**RE: Goddard Pit #1, M-2018-050, 111(c) Permit Application  
Adequacy Review No. 1**

# Goddard Pit #1, M-2018-050, 200 Foot Buffer Map

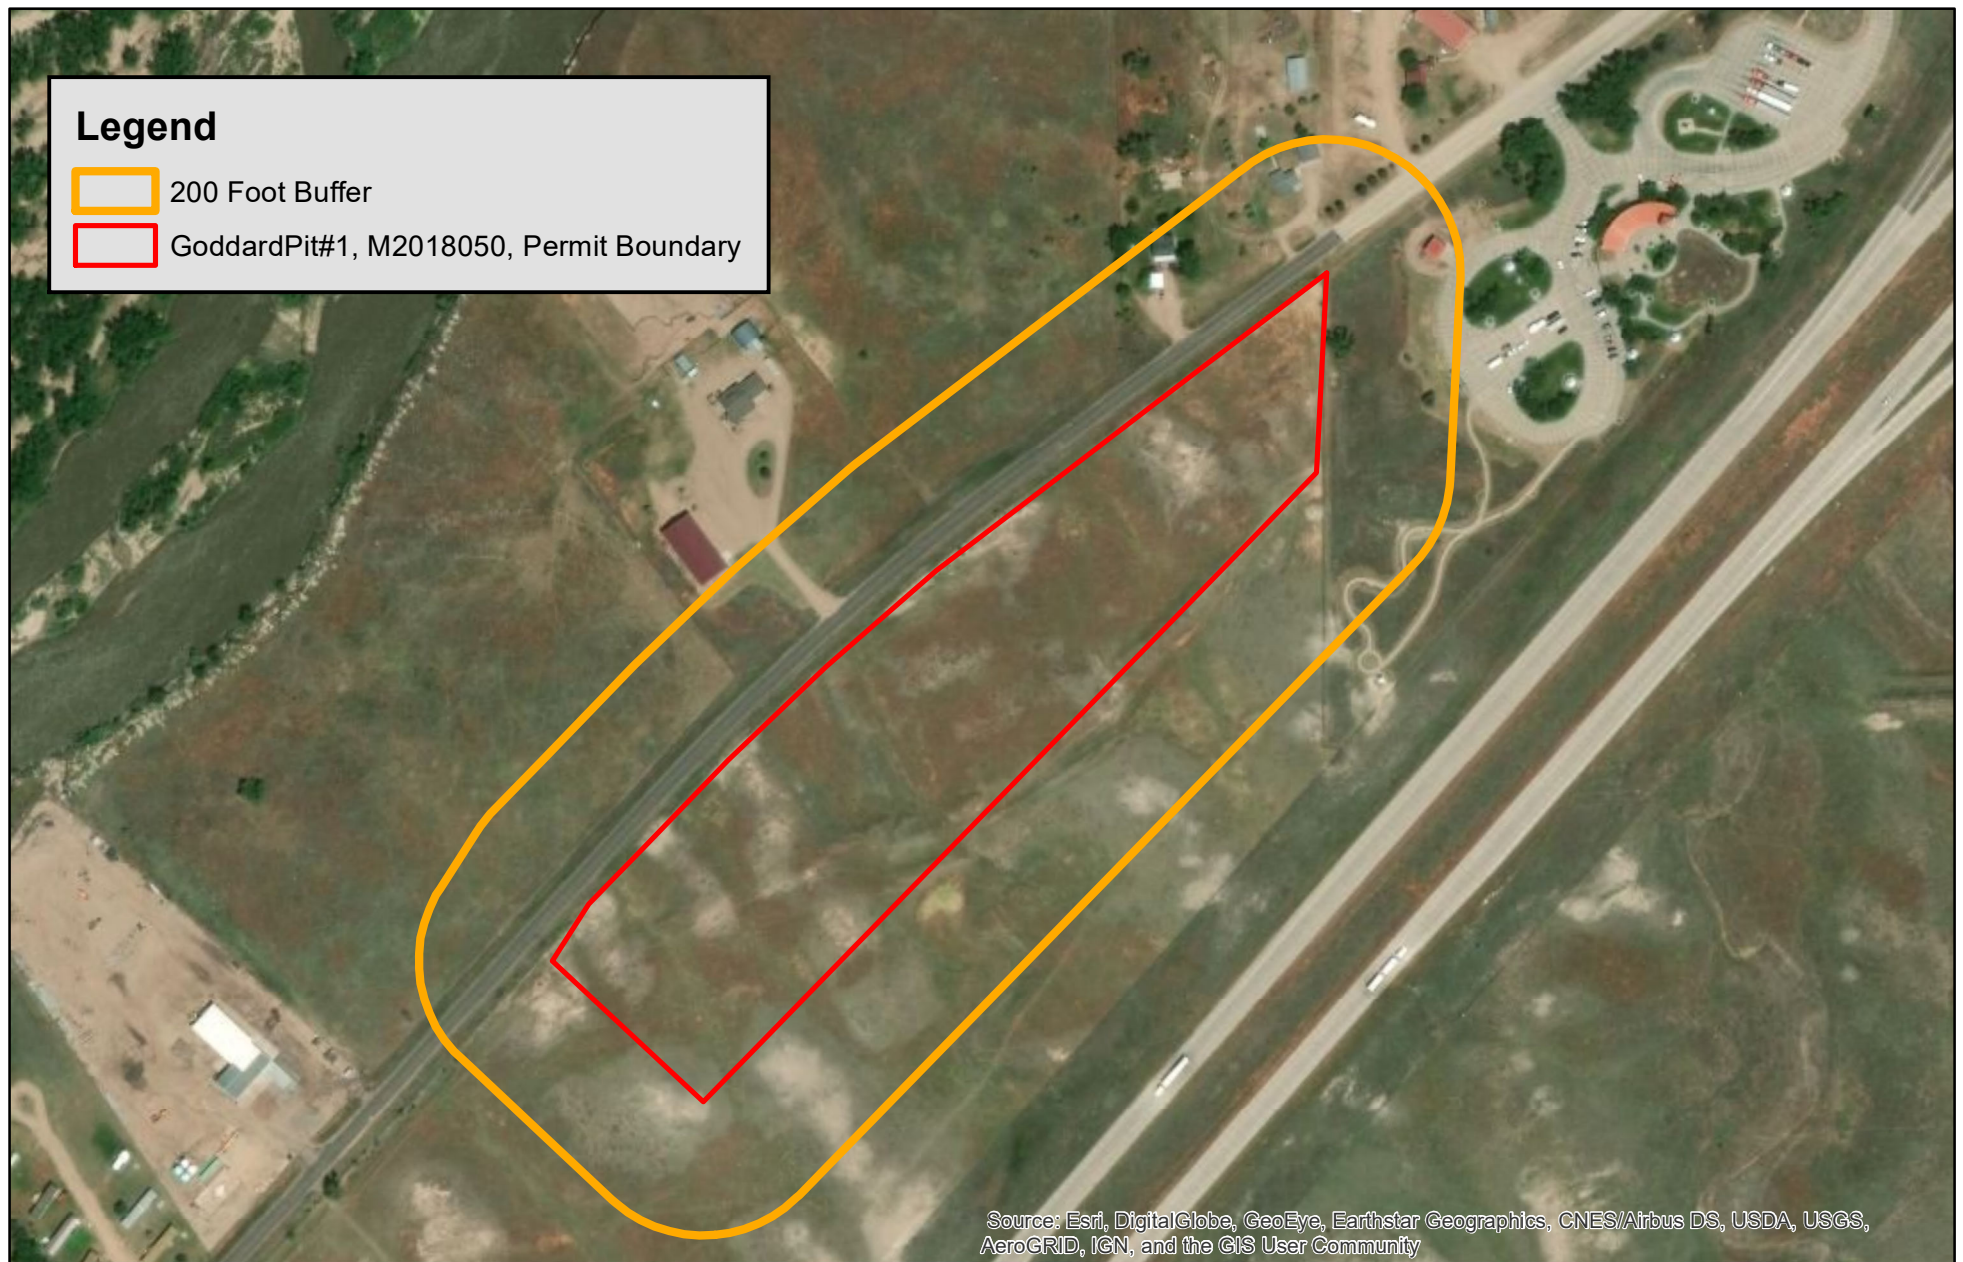
- 2.) Based on the soils series description for the site, there is a viable A and B horizon eight inches deep. Please revise Exhibit B to indicate the soil depth is eight inches at the site or provide further justification for only designating the top four inches as topsoil.
- 3.) Attached is a map that the Division created with the permit boundary depicted and a 200 foot buffer around the proposed affected area. There appears to be more permanent man-made structures within 200 feet of the affected area than was identified in the application. Based on the Division's review, these are the structures within 200 foot of the affected land not included in the application:
  - a. Driveway into Reicks property
  - b. County Road 28
  - c. Driveway into Mendoza property
  - d. Two buildings on Mendoza property
  - e. Two building on Bieber property

- f. Driveway into Beiber property
- g. Building on Department of Highway's property
- h. Parking Lot on Department of Highways Property
- i. Path on Department of Highway's property.

Please revise exhibit B to list these structures that are located within 200 feet of the affected land.
